BOARD MEETING AGENDA

Board Room
Coon Creek Watershed District Offices
Monday, June 26, 2023
5:30 p.m.

COON CREEK WATERSHED DISTRICT BOARD OF MANAGERS' MEETING

Figure 2. Erosion and Sediment Control Plan

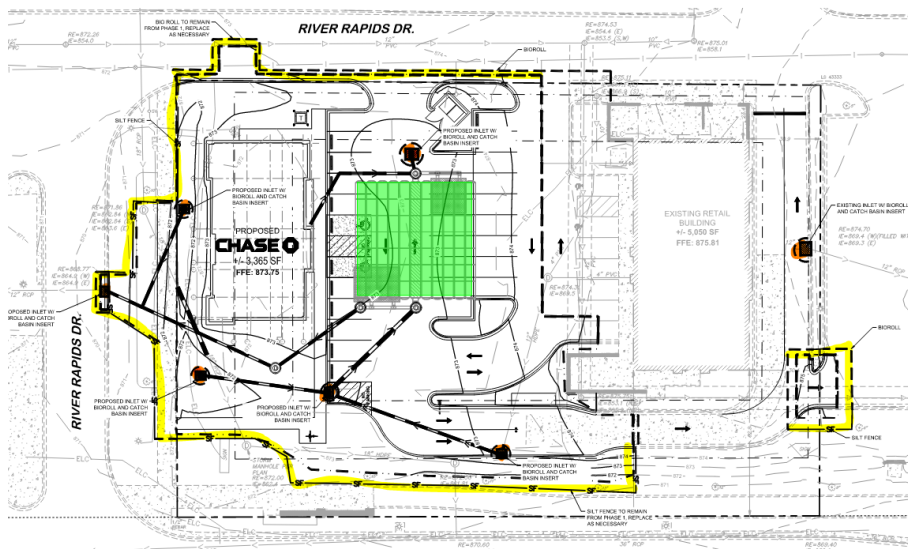
Rule 4.0 applies to the proposed project because it includes land disturbing activities of 1 acre or more. The proposed project drains east to Coon Creek. The soils affected by the project include Urban which do not have a soil erodibility factor of 0.15 or greater. Disturbed areas are proposed to be stabilized within 7 days, as required. The proposed erosion and sediment control plan includes perimeter control, street sweeping, and inlet protection. The erosion control plan meets District Requirements.

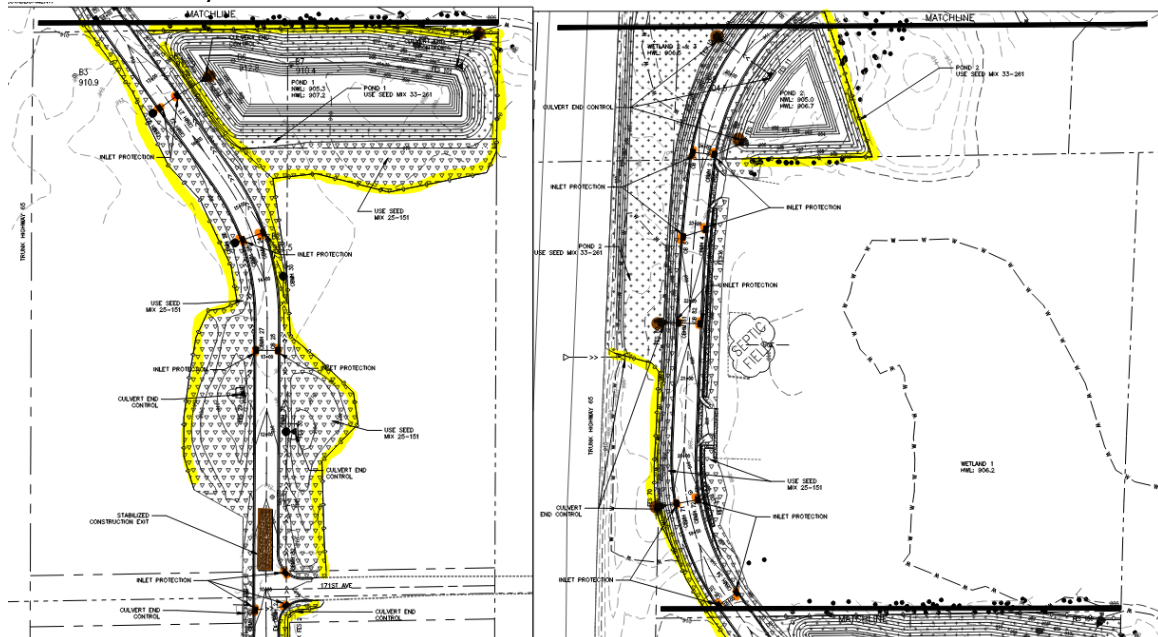
The proposed project drains to County Ditch 58-3-1. The soils affected by the project include Soderville, Isanti, Lino, Zimmerman, and Cut & Fill which have a soil erodibility factor of 0.15 or greater. Disturbed areas are not proposed to be stabilized within 24 hours, as required. The proposed erosion and sediment control plan includes silt fence, rock construction entrance, riprap, seeding, and inlet protection. The erosion control plan does not meet District Requirements. The plan does not meet requirements because soil and soil stockpiles are not proposed to be stabilized within 24 hours of inactivity.

Figure 2. Erosion and Sediment Control Plan

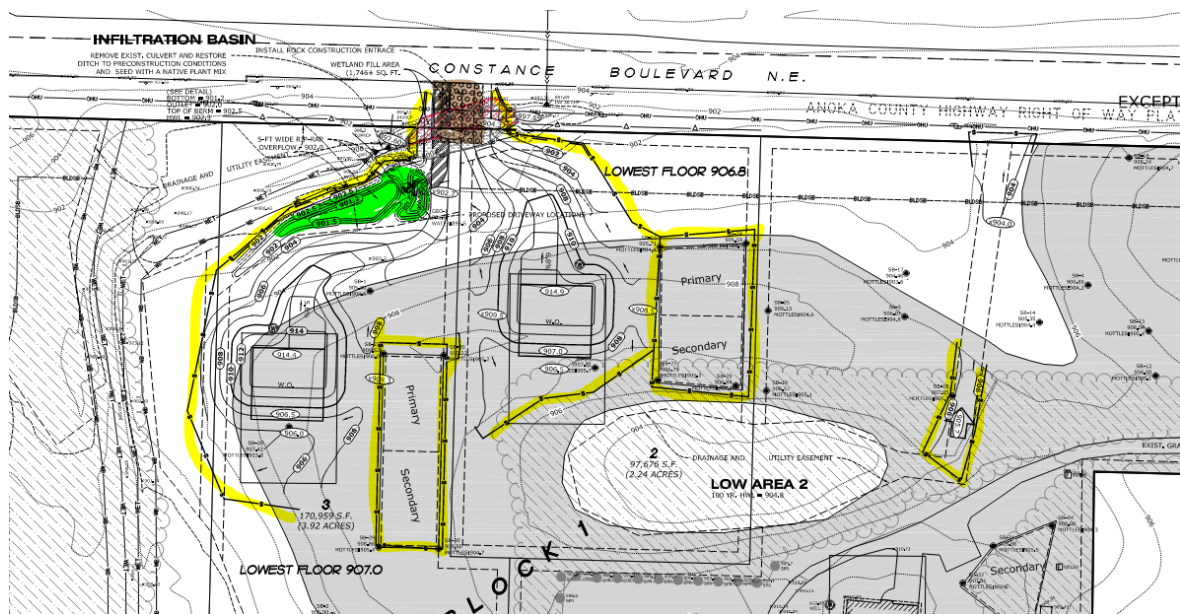
Rule 4.0 applies to the proposed project because it includes land disturbing activities of 1 acre or more. The proposed project drains to a private ditch and then to Coon Creek. The soils affected by the project include Rifle, Markey, Isanti, and Zimmerman and have a soil erodibility factor of 0.15 or greater. Disturbed areas are not proposed to be stabilized within 24 hours, as required. The proposed erosion and sediment control plan includes silt fence and rock construction entrance. The erosion control plan does not meet District Requirements because soils and soil stockpiles are not proposed to be stabilized within 24 hours of inactivity and perimeter control is not proposed around the infiltration basin.
